Re: Protested Applications in the name of Timothy P. Deeg, referred to as Transfer
No. 71132, and Amendment of Permits Nos. 41-7076 and 41-7081,

MEMORANDUM

SUBJECT: RE-CALULATION OF ACRES WATER RIGHTS 41-7076 & 41-7081

REVIEW OF ACRES - ATTACHMENT B

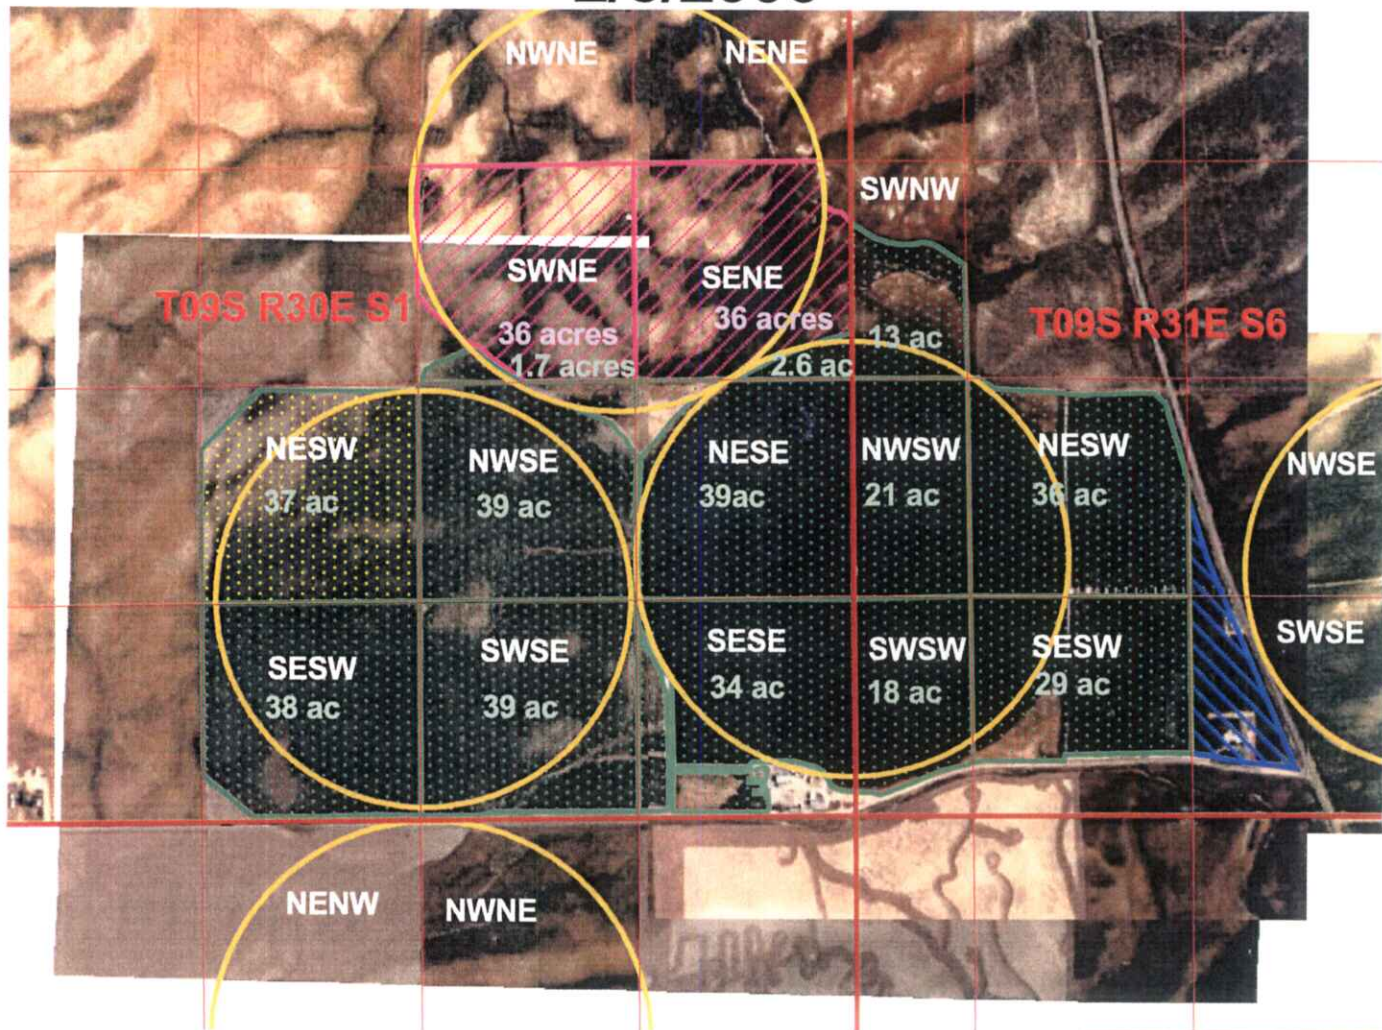
Please see Attachment B for the ArcView shapes that I created using the 1994 aerial photo. My new shape file revealed that there were 347.3 acres actually irrigated instead of the 338 originally recommended. Brockway found 358.5 acres, but the difference between Brockway and my calculations were generally due to rounding, and line placement except for the lands in the SE and NE of Section 1. The permit also limits the total acres allowed to 348 acres, so my new calculations will give Mr. Deeg very close to the maximum amount allowable under 41-7081.

Brockway did not take into account overlapping water rights when creating his shape files, so there are a couple of discrepancies. There is approximately 9.4 acre in the SE S6 that are covered under water right 41-7071. Mr. Brockway included these acres in his total acre calculations when they were covered by another right.

The above maps show the re-calculated place of use for water right 41-7081. The aerial photo is a 1994 aerial photo supplied by Brockway Engineering. Brockway Engineering determined that some acres hadn't been accounted for in the original field exam. This is true in some cases, but Brockway Engineering neglected to take into account the other rights on the property. Brockway included lands irrigated by 41-7071 in the NWSE and SWSE of Section 6. They also included lands irrigated in the SENE S1 under water right 41-7030. Water right 41-7071 existed before this permit and 41-7030 was transferred to this property at approximately the same time, so the acres for both these rights needed to be removed before acres could be allocated to this permit. I have increased the total number of acres by approximately 9.4 cres. These acres are mainly found in the NESW and SESW of S1. The remaining 40 acre tracts were increased mainly due to new rounding protocol.

I RECOMMEND THAT FIELD EXAM RECOMMENDATION BE CORRECTED TO SHOW THE ADJUSTED ACRES IN ATTACHMENT D. THE DIVERSION RATE WAS BASED ON A SYSTEM CAPACITY, SO IT SHOULD NOT CHANGE. THE VOLUME WAS BASED ON THE ACRE AMOUNT, SO THE VOLUME SHOULD BE CHANGED TO 1389.2 AFA.
